**Subject: Second Postscript for Notes of Tele-conference 9 January 2006 --
Three Mile Island Reactor Accident:**

**The Significance of the large Temperature Difference between the
inlet and outlet Reactor Coolant of the TMI-2 Reactor at 18 Hours
into the Accident; and**

**the Inadequacies of the Post-Accident Reactor Examination and the
official Analysis of what happened in the Accident.**

106 hours TMI-2 Accident

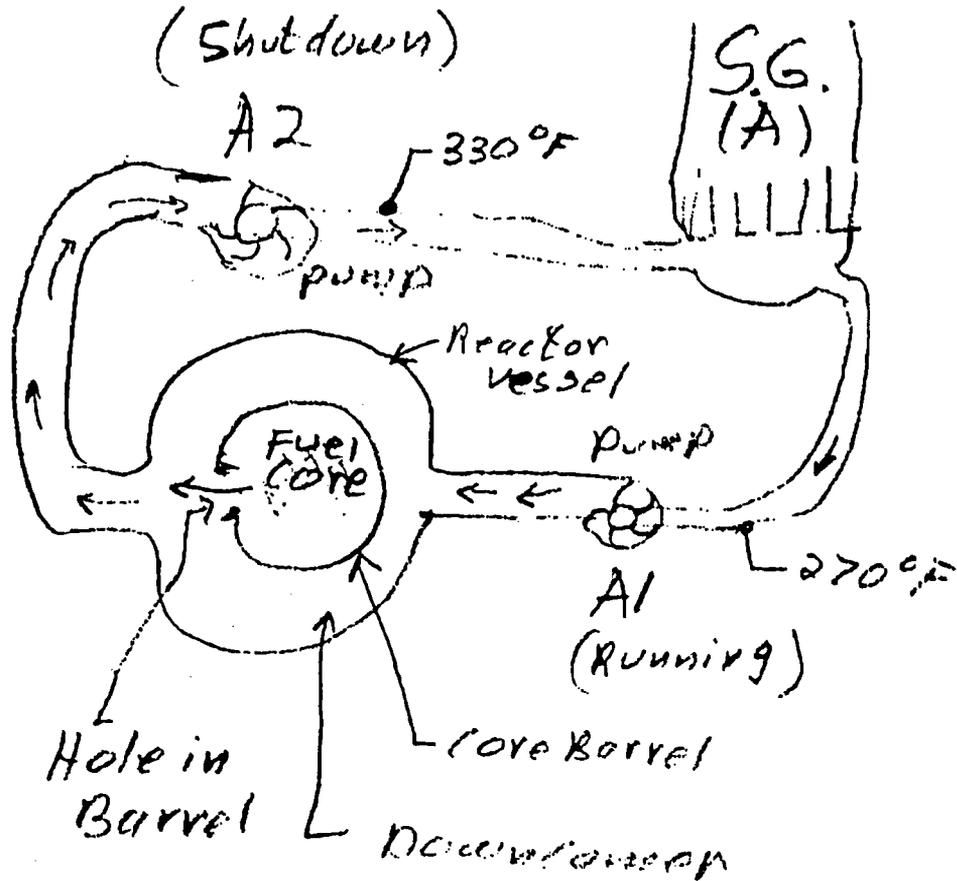
I offer a sketch of my idea of a hold in the core barrel; but it represents also a more circuitous path through the core region to the inlet nozzle of 2A. By the way, I assume that the electrical power to the running coolant pump was 6.7 MW, which is about half of the core decay heat; and the rise in temperature of the coolant due to that electric power would be about 0.5 degrees Fahrenheit, if the flow were 28 million pounds per hour, which I doubt. I am wondering what basis the Rogovin commission asserted that flow value?

Fig. 1 TMI-2 reactor vessel end-state configuration.

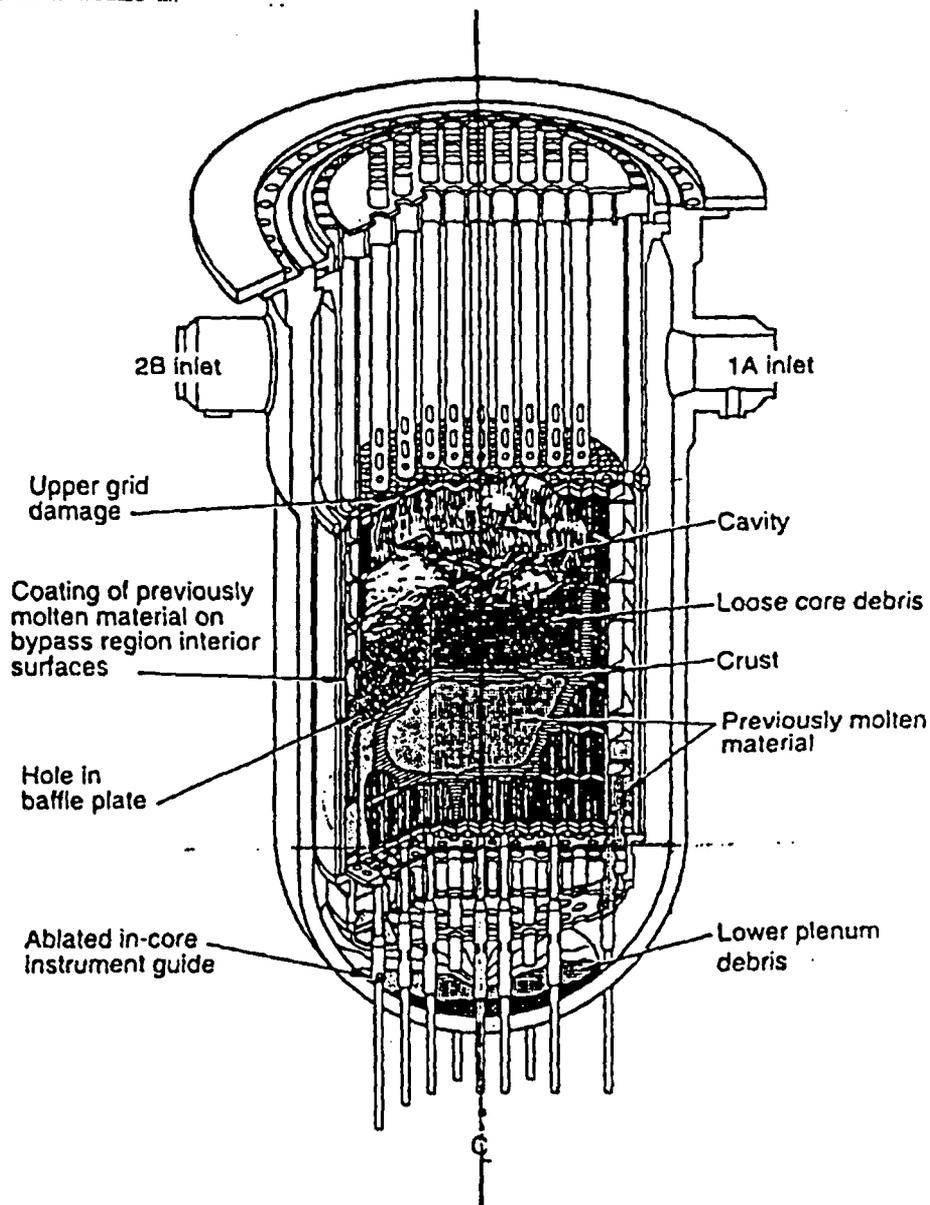
The A-Loop cold legs drew their water from the plenum of the A-Loop Steam Generator, and yet the temperature of the 2A leg is higher, and much higher, than the leg 1A. I assume that there is a back flow through the 2A pump, since it was not running. So, I think that there must have been a hole in the core barrel such that the coolant flow that went up into the core, coming from the discharge of the 1A pump that was running, divided into two branches: one branch flowed up and out of the core, being heated in the process, to explain the 325 °F hot leg temperatures; while the other branch exited the postulated hole, to enter the inlet nozzle for the 2A leg. The 2nd branch of core flow formed a part of the back flow through the 2A pump. Having flowed through much of the core region, that back flow was heated by the core decay heat. The Rogovin Report, page 490, gives a schematic drawing of the TMI-2 reactor coolant system, and that shows that the reactor vessel inlet nozzle from the 2A cold leg is almost diametrically opposite from

the inlet nozzle of the 1A cold leg; and indeed, the drawing of the "end-state configuration" of the TMI reactor core and vessel internals given in the August 1989 Nuclear Technology article on "A Scenario ..." by Broughton and others, reprinted in Nuclear Safety, Vol. 35, No. 2, shows a hold in the "baffle plate" at the 2B inlet nozzle side of the vessel; though no hold through the core barrel. Perhaps the flows were very circuitous in the core region, due to a possible massive destruction by then. (This analysis goes further to prove the necessity of leaving a main coolant pump running, and not switch it off.)
